UNITED STATES  
NUCLEAR REGULATORY COMMISSION

ORGANIZATION: NUCLEAR ENERGY INSTITUTE (NEI)

SUBJECT: SUMMARY OF MEETING WITH THE NEI ON THE INTERNATIONAL  
NUCLEAR EVENT SCALE (INES) RATINGS

## NEI Review of NRC Participation in the International Nuclear Event Scale

Sheet 3  
Subprocedure on-site

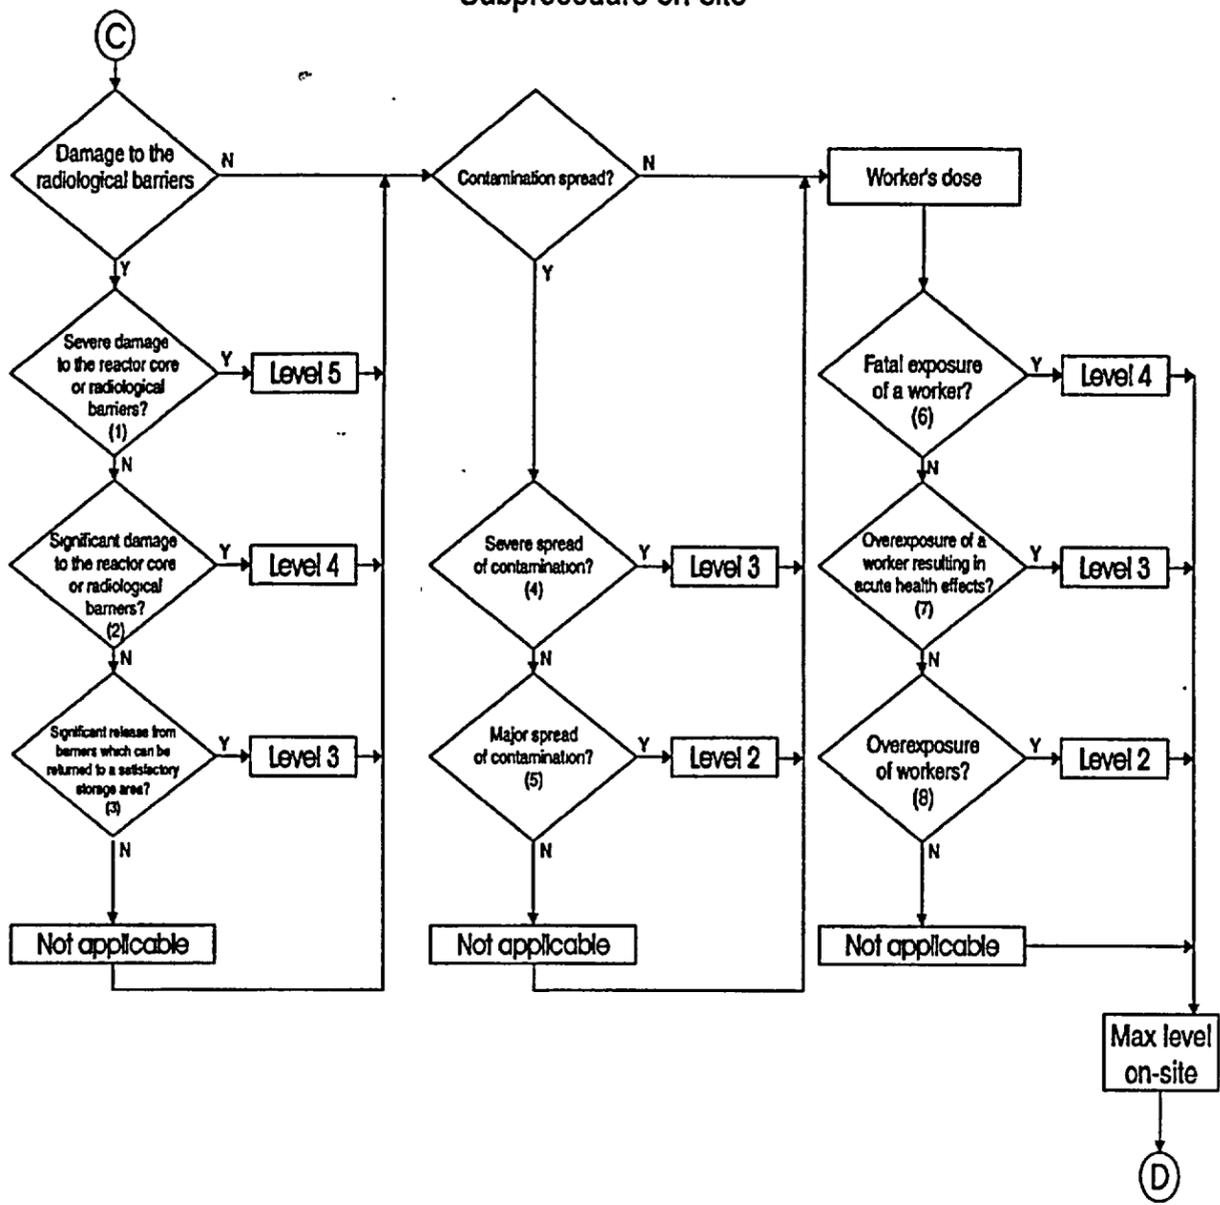
# On-Site Impact Level 5 Clarification

## **Definition and Sheet 3 Note 1: Severe Damage to the reactor core or radiological barriers**

## **Recommended Change:**

# On-Site Impact Level 4 Clarification

## **Recommended Change:**

# On-Site Impact Level 3 Clarification

## **Change Justification:**

A major release of radioactivity requiring offsite protective actions is not possible unless the containment barrier fails subsequent to a major failure of fuel cladding allowing radioactive material to be released from the core into the reactor coolant. 20 per cent fuel gap release is a value which indicates severe fuel damage. Regardless of whether containment is challenged, this amount of activity in containment, if released, could have such severe consequences that it is prudent to treat this as a potential loss of containment. NUREG-1228, "Source Estimations During Incident Response to Severe Nuclear Power Plant Accidents," indicates that such conditions do not exist when the amount of clad damage is less than 20%. This definition is consistent with the Emergency Action Level (EAL) classification methodology of NEI 99-01, Revision 4, for a General Emergency. Short-term, the evaluation of whether the activity release is a result of damaged clad due to fuel melting is irrelevant and would require either non-ALARA sampling/analysis and/or possible visual fuel inspection to determine.

## **Change Justification:**

A release of radioactivity requiring on-site protective actions from core damage is not possible unless the containment barrier fails subsequent to a partial failure of fuel cladding allowing radioactive material to be released from the core into the reactor coolant. 5 per cent fuel gap release (reactor coolant activity  $>300 \mu\text{c}/\text{cc DEI}$ ) is a concentration indicative of fuel damage several times larger than the maximum fuel leakage (including iodine spiking) allowed within technical specifications and is therefore indicative of significant fuel damage. This definition is consistent with the Emergency Action Level (EAL) classification methodology of NEI 99-01, Revision 4, for a Site Area Emergency. Escalation to level 5 would occur should activity levels rise to a 20% value. Short-term, the evaluation of whether the activity release is a result of damaged clad due to fuel melting is irrelevant and would require either non-ALARA sampling/analysis and/or possible visual fuel inspection to determine.

**Change Justification:**

A release of radioactivity requiring on-site protective actions from core damage is not possible unless a partial failure of fuel cladding allows radioactive material to be released from the core into the reactor coolant. 5 per cent fuel gap release (reactor coolant activity  $>300 \mu\text{c}/\text{cc}$  DEI) is a concentration indicative of fuel damage several times larger than the maximum fuel leakage (including iodine spiking) allowed within technical specifications and is therefore indicative of fuel damage. With the fuel activity contained within the reactor coolant system, contamination spread may be controlled and activity levels may be reduced through installed isolation and cleanup systems. This definition is consistent with the Emergency Action Level (EAL) classification methodology of NEI 99-01, Revision 4, for an Alert Emergency. Escalation to level 4 would occur should significant reactor coolant leakage into containment subsequently occur.

### Sheet 3 Subprocedure on-site

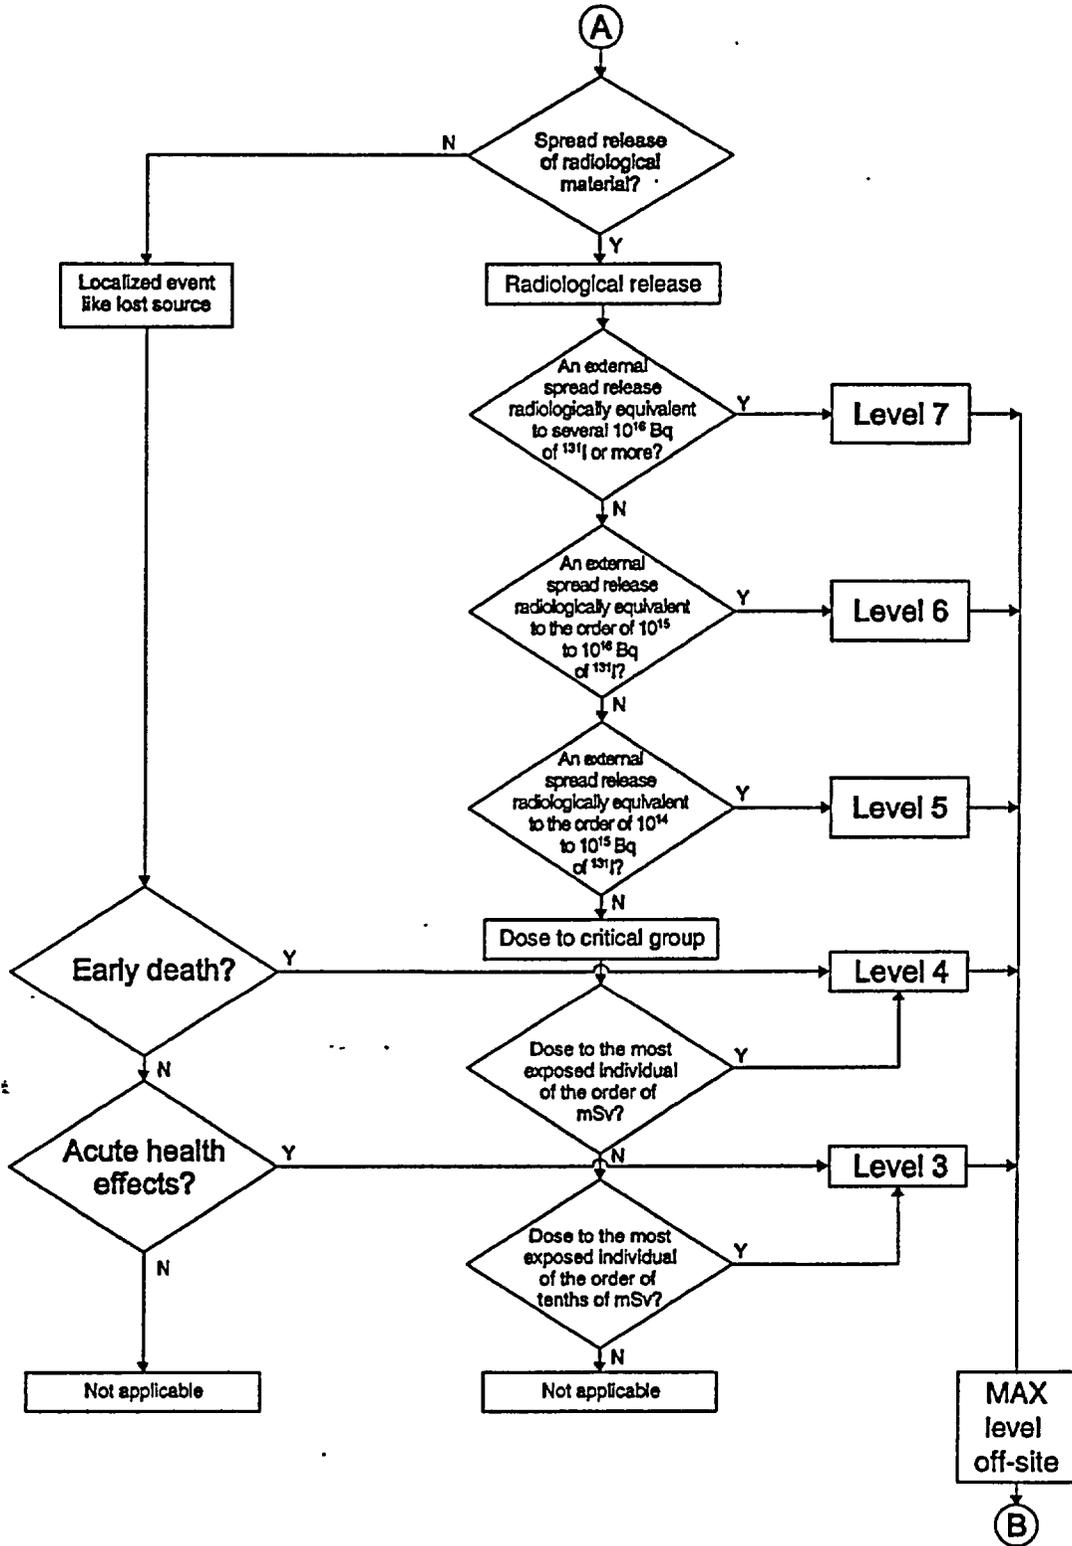
## Notes for Sheet 3:

1. More than a few per cent of the fuel in a power reactor is molten or more than a few per cent of the core inventory has been released from the fuel assemblies. Incidents at other installations involving a major release of radioactivity on the site (comparable with the release from core melt) with a serious off-site radiological safety threat.

## Recommended Change:

## Change Justification:

A major release of radioactivity requiring offsite protective actions is not possible unless the containment barrier fails subsequent to a major failure of fuel cladding allowing radioactive material to be released from the core into the reactor coolant. 20 per cent fuel gap release is a value which indicates severe fuel damage. Regardless of whether containment is challenged, this amount of activity in containment, if released, could have such severe consequences that it is prudent to treat this as a potential loss of containment. NUREG-1228, "Source Estimations During Incident Response to Severe Nuclear Power Plant Accidents," indicates that such conditions do not exist when the amount of clad damage is less than 20%. This definition is consistent with the Emergency Action Level (EAL) classification methodology of NEI 99-01, Revision 4, for a General Emergency. Short-term, the evaluation of whether the activity release is a result of damaged clad due to fuel melting is irrelevant and would require either non-ALARA sampling/analysis and/or possible visual fuel inspection to determine.

Figure 3.4.16-1

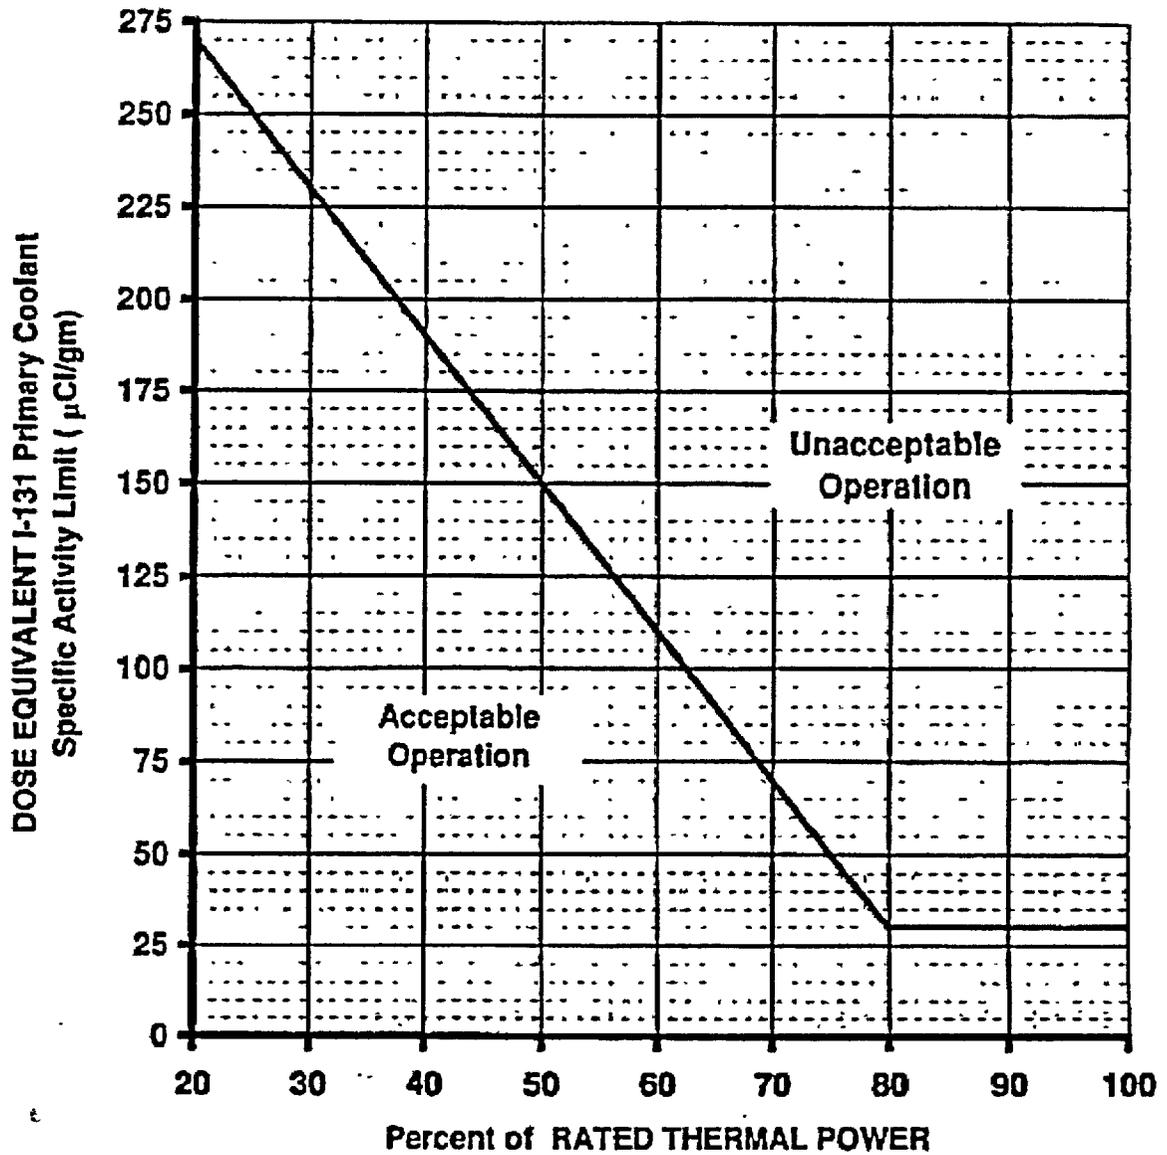
# PWR Technical Specification Example

*25  $\mu\text{Ci/gm}$*
